HIGHWAY WORK PROPOSAL

Marinette 1150-64-71 N/A Peshtigo-Marinette; Peshtigo Bypass-**USH 041**

Addendum No. 02 ID 1150-64-71 **Revised Sheet 112** December 5, 2023

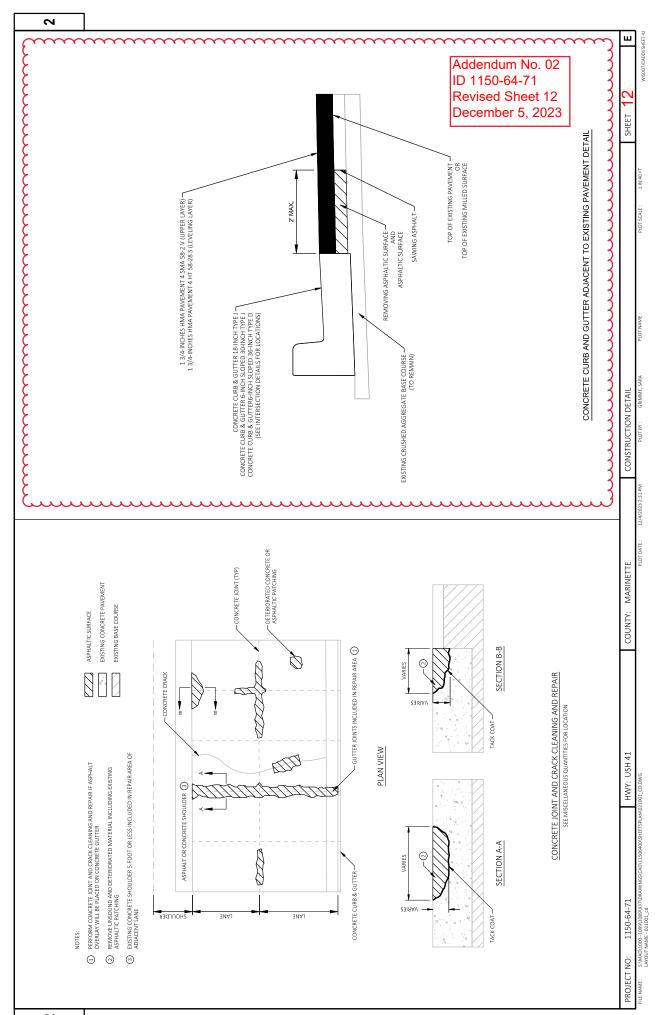
Revised Plan Sheets
Plan Sheet	Plan Sheet Title (brief description of changes to sheet)
12	Construction Details: Added Concrete Curb and Gutter Adjacent to Existing Pavement Detail.
107	Miscellaneous Quantities: Added Removing Asphaltic Surface table.
108	Miscellaneous Quantities: Added Sawing Asphalt and Sawing Concrete to Removing Curb & Gutter table
110	Miscellaneous Quantities: Added "Additional Quantities Listed Elsewhere" note to Base Patching Concrete and Concrete Joint and Crack Cleaning and Repair table
